19000646.00 6/2/2020 9:53:36 AM COOPER ACADEMY KITCHEN HVAC ADDITION

Fresno Unified School District, **Cooper Academy Elementary School Kitchen HVAC Addition (A#02-118216).**

Please see the following addendum for Mechanical systems.

All revisions to drawings are indicated by cloud and delta No.1

REMODEL ROOF PLAN

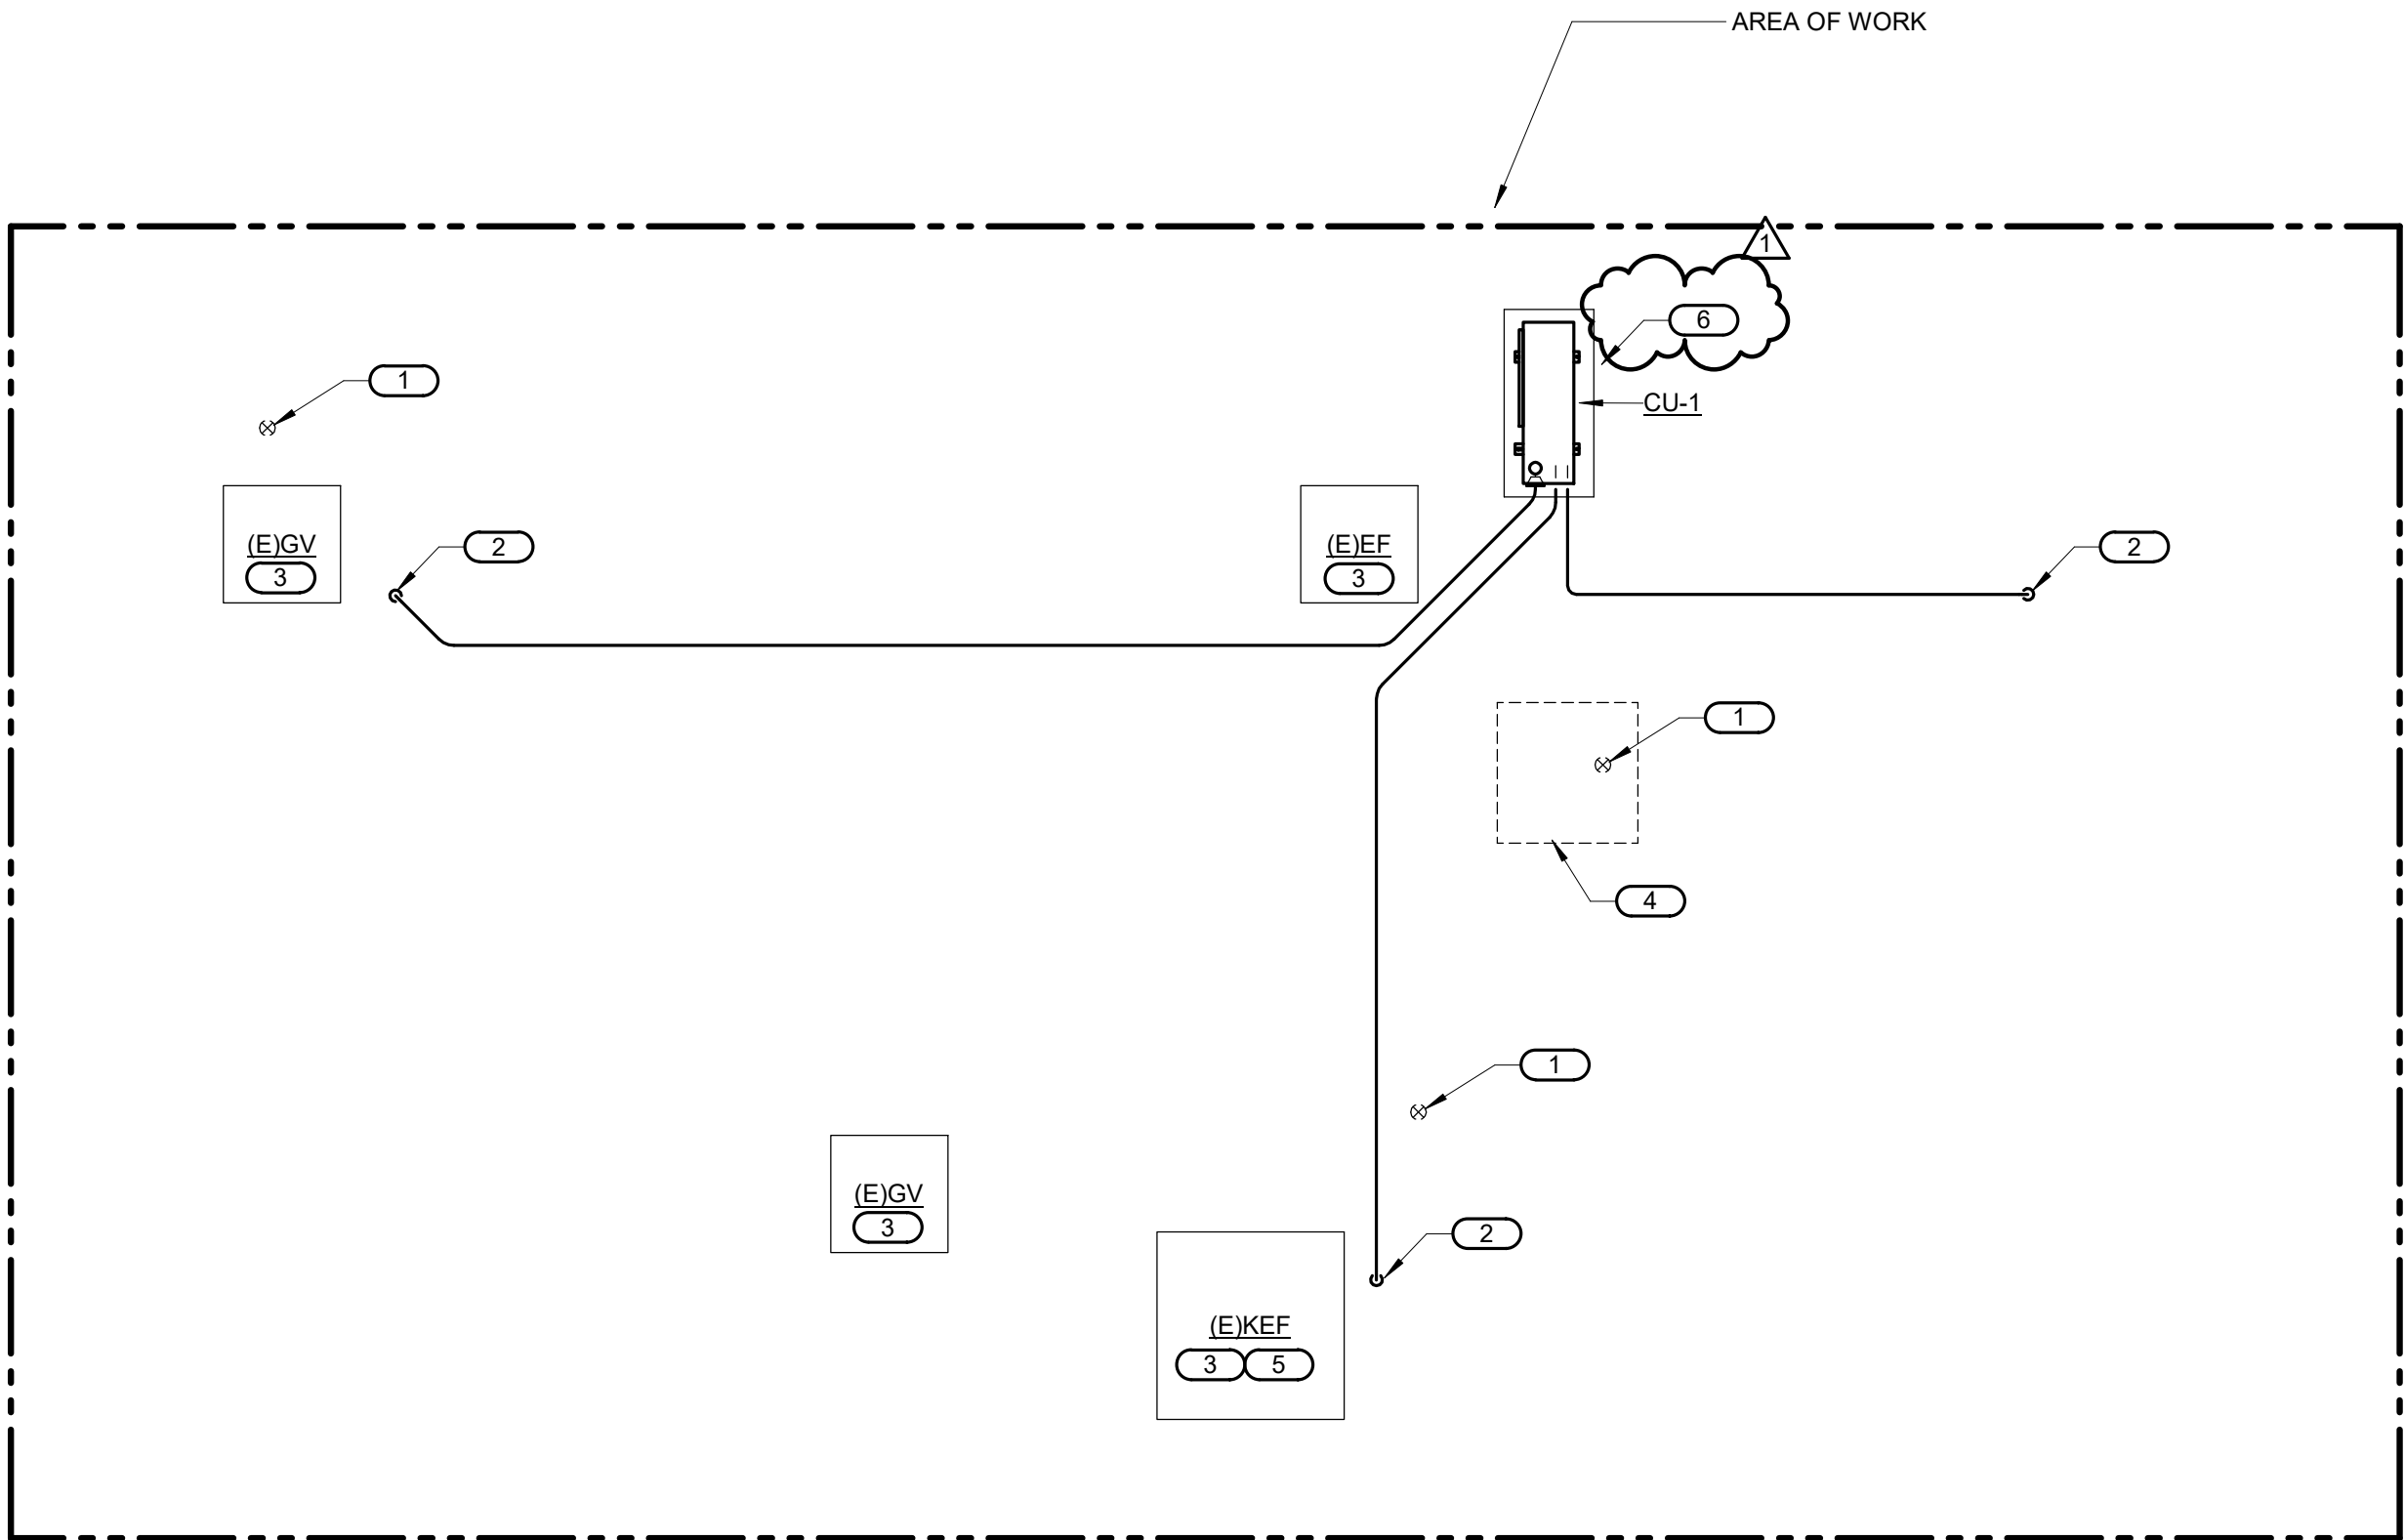
- A. Modified demolition keynotes.
- 1.3 SHEET M3.1
  - A. Modified keynotes.
  - B. Added general note.
- 1.4 SHEET M3.2
  - A. Added keynote 6.
- 1.5 SHEET M4.1

SPRAYED POLYURETHANE FOAM, CONDUIT SUPPORT

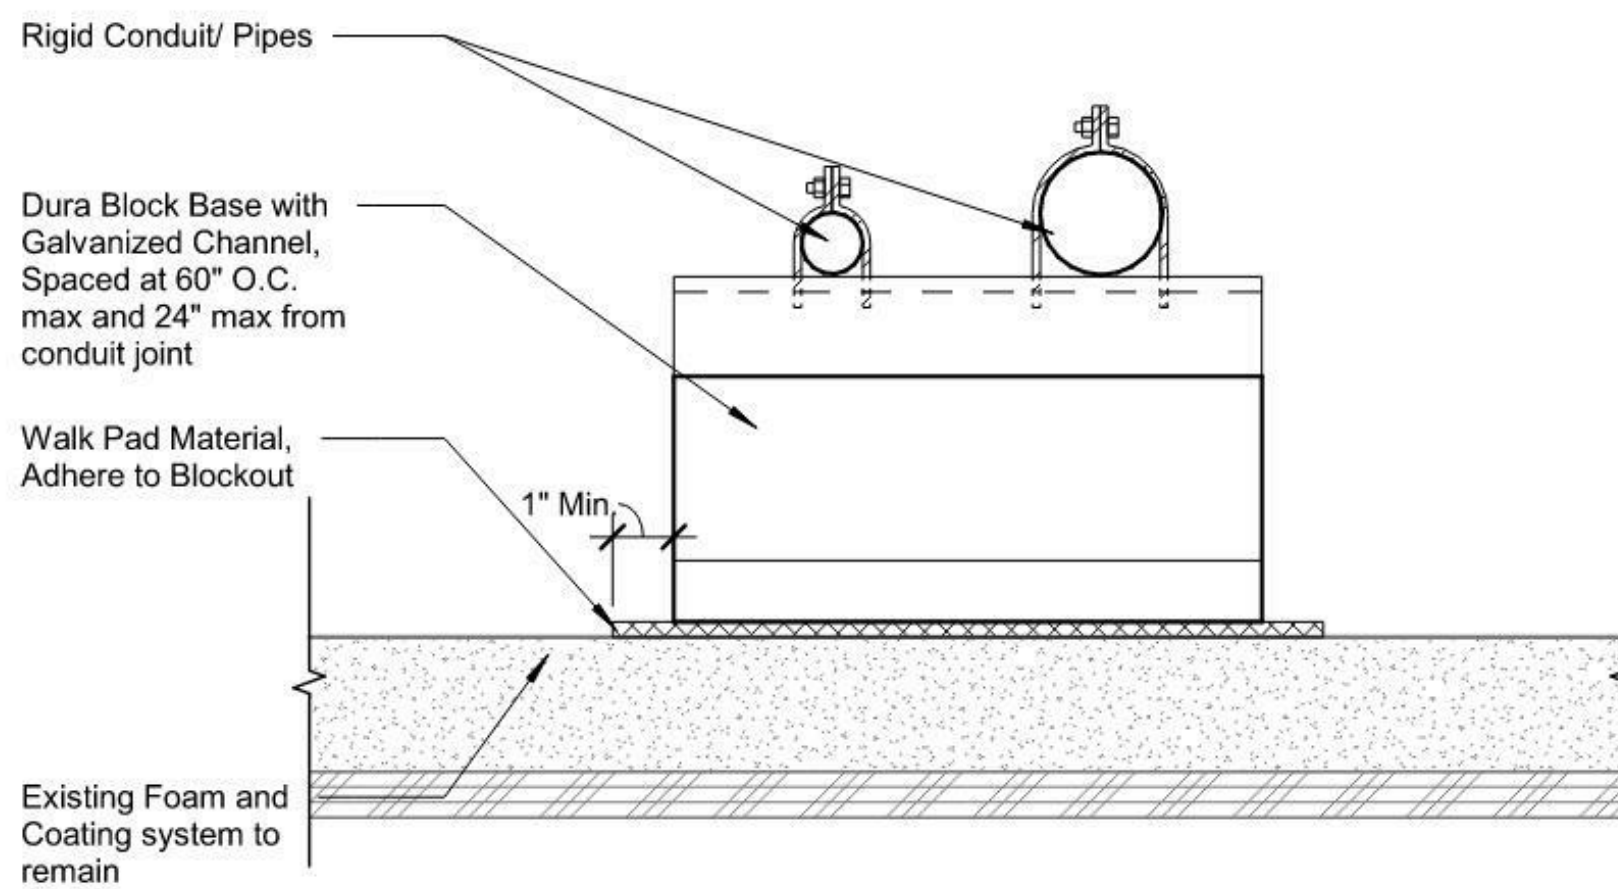
- C. Modified detail 6 "Condensate Connection To Lavatory."
  - D. Modified detail 8 "Sprayed Polyurethane Foam, Conduit Support" to FUSD approved detail.

NOT USED			NTS	6	SPLIT SYSTEM WIRING DIAGRAM			NTS	3	EMS SYSTEM NETWORK			NTS	1
NOT USED			NTS	7	CONTROL WIRING LEGEND			NTS	4	FC-1/2 AND CU-2 CONTROL DIAGRAM			NTS	2
NOT USED			NTS	8	NOT USED			NTS	5	NOT USED			NTS

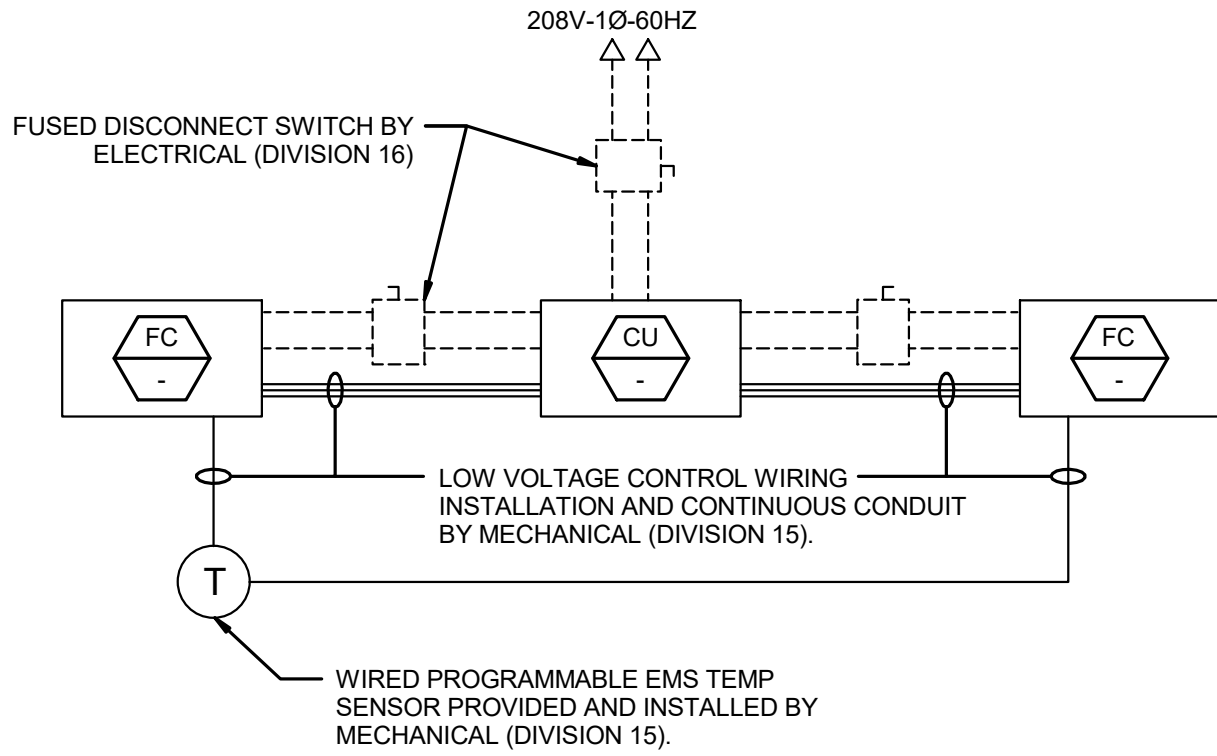
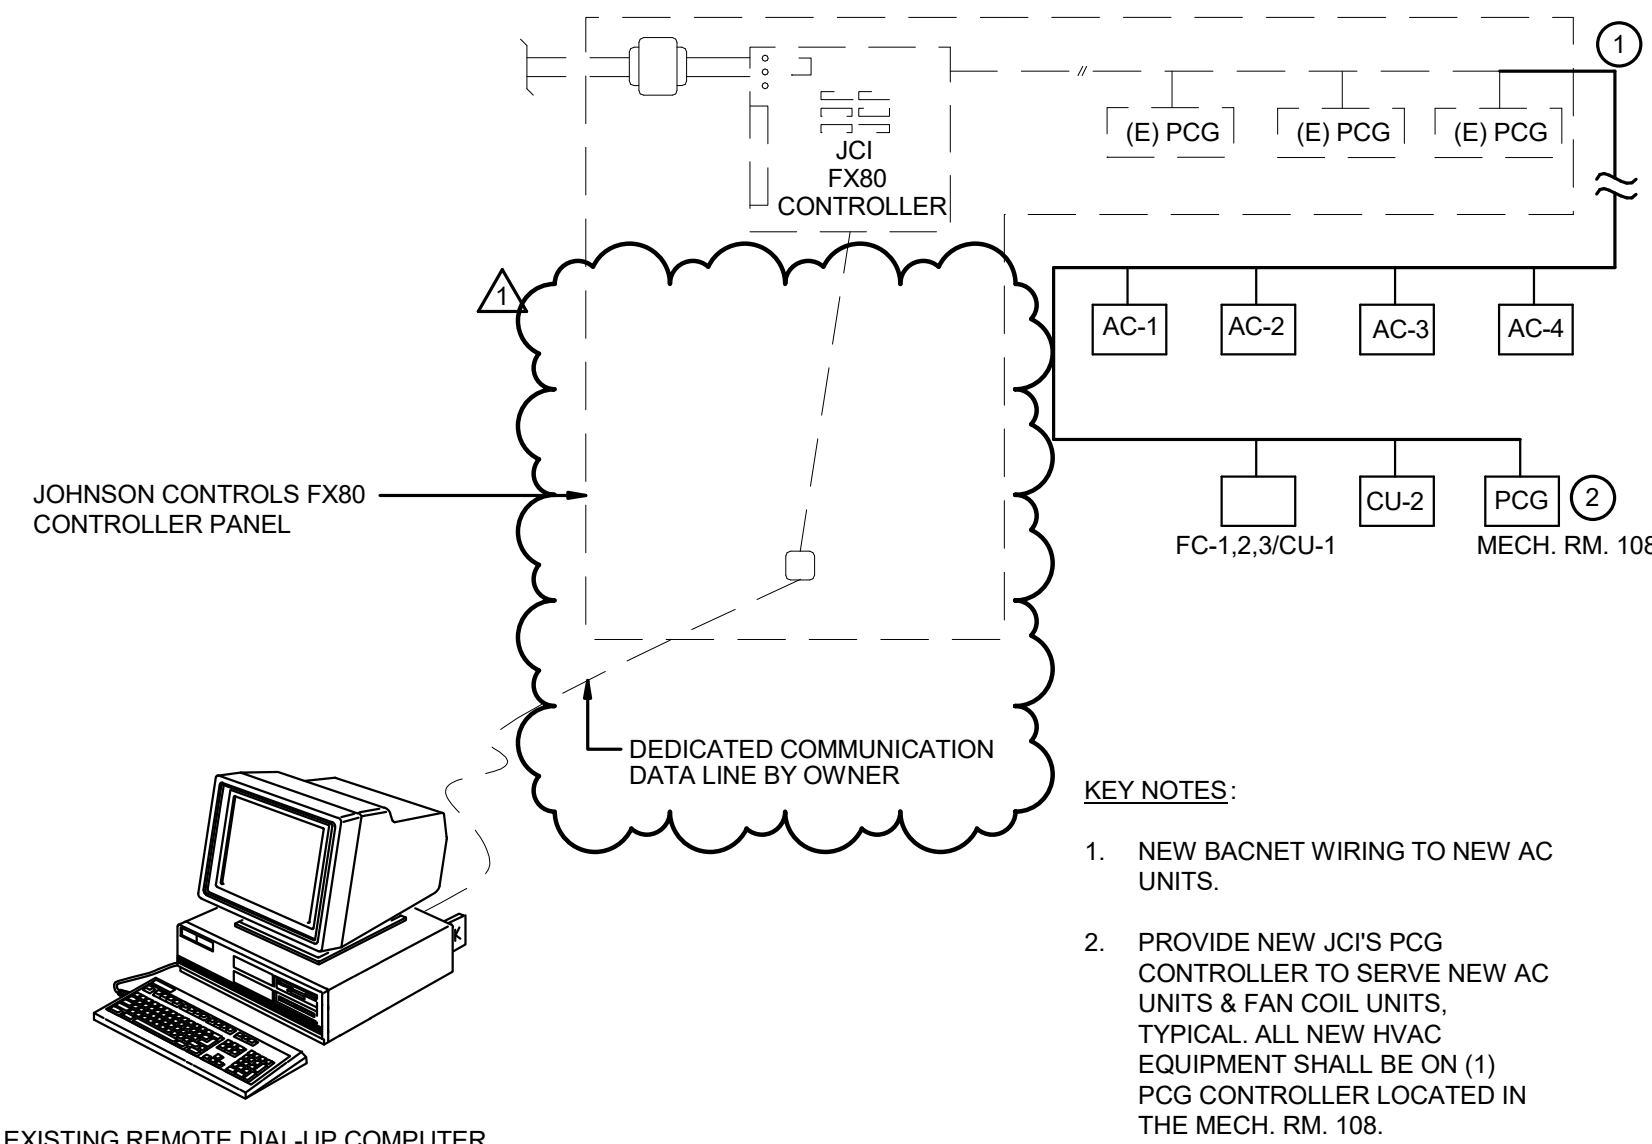
- 1.7 SHEET M5.1
  - A. Relocated "Split System Wiring Diagram" from Sheet M4.2 Detail 4 to Sheet M5.1 Detail 3.
  - B. Relocated "Control Wiring Legend" from Sheet M4.2 Detail 3 to Sheet M5.1 Detail 4.
